U8032A-01

S E R V I C E N O T E

U8032A DC Power Supply

U8032A's Voltage Programming Speed drifts out of warranted specification within the product's calibration period

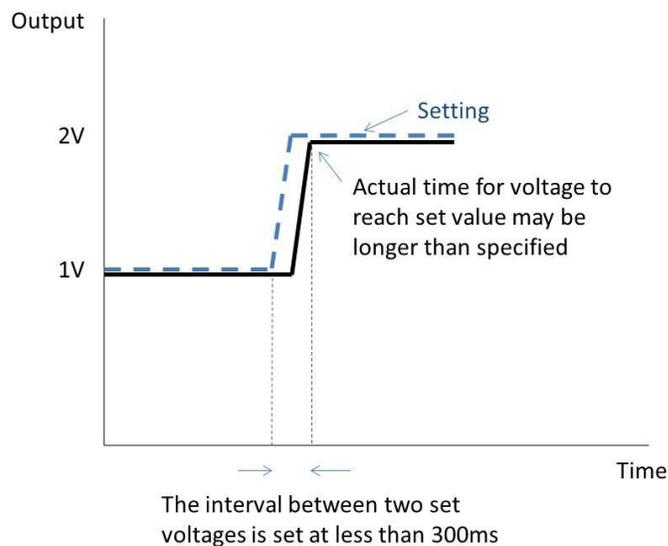
Agilent has recently discovered a batch of U8032A DC Power Supply where its Voltage Programming Speed may drift out of the warranted specifications within the product's calibration period. This behavior is observed ONLY when customers use the Output Sequencing feature on Output1 and Output 2.

Customers may notice a longer response time for the U8032A to reach the subsequent set voltage level if the set interval duration between the two voltage settings is less than 300ms, as illustrated in the diagram below.

This situation does not occur if the set interval duration is $>300\text{ms}$.

Customers with U8032A serial numbers stated above should contact the nearest Agilent Service Center to have their instruments exchanged ONLY if the unit exhibits the symptom described above.
